# Access Compliance Report

## Public Rights-of-Way

Intersection ID: 5967	Main Street: N_TRYON_ST	Cross Street: MCCULLOUGH_DR	Location: NE
ADA ID: 948AFDAF576F	Ramp Type: BlendTrans1	Initial Pass/Fail: Fail	Overall Compliance: No
Severity Score: 8.75			
Codes/Mitigation Info/Possible Solution		Field Measurements/Component Compliance

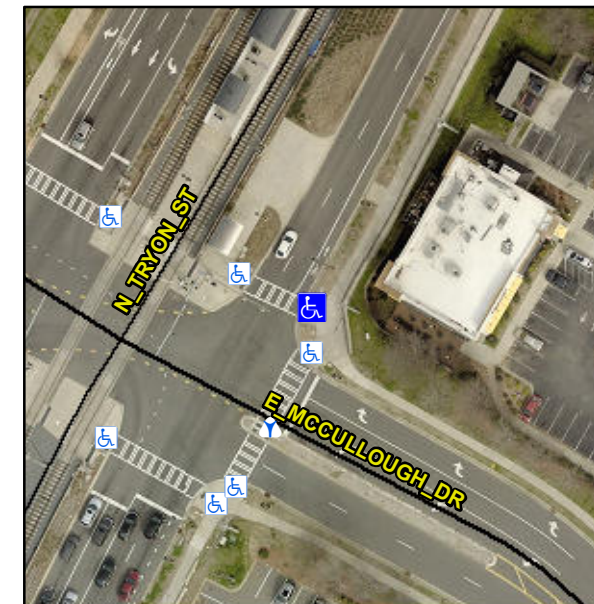
**Not Found, R304.5.1**

**Remove & Replace Curb Ramp With Two New Directional Ramps or Equivalent.**
